CITY OF PORTLAND Planning and Urban Development Department

SUBJECT: 74 Bay Street

CITY OF PORTLAND

RE: 74 Bay Street

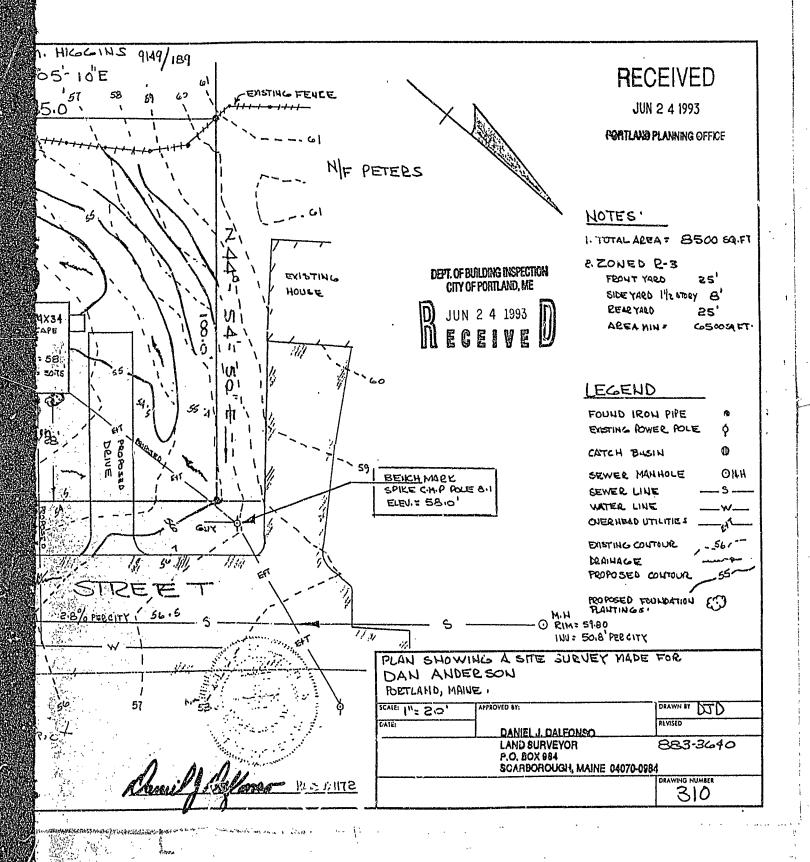
CITY OF PORTLAND, MAINE SITE PLAN REVIEW (ADDENDUM) CONDITIONS OF APPROVAL

| APPLICA | NT: Julie anderson |
|--|--|
| Ø | drainage ple plan received 6/24/93. |
